P802.3z Draft 4 Comments

39.6.8 Differential TDR measurement procedure

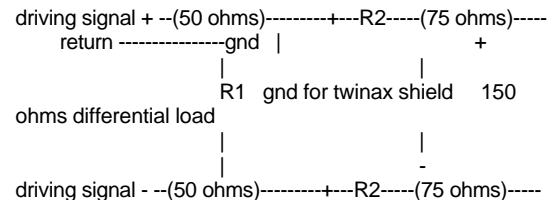
Since no international standards have been located on how to make these measurements, the following text is proposed as an addition to clarify the usage of these tests.

The differential time-domain reflectometry (TDR) test setup measures the reflected waveform returned from a load when driven with a step input. It is obtained by driving the load under test with a step waveform using a driver with a specified source impedance and risetime. The reflected waveform is the difference between (a) the observed waveform at the device under test when driven with the specified test signal, and (b) the waveform that results when driving a standard test load with the same specified test signal. From this measured result we can infer the impedance of the device under test. The time-domain reflectometry measurement is the time-domain equivalent of S11 parameter testing used in carrier-based systems.
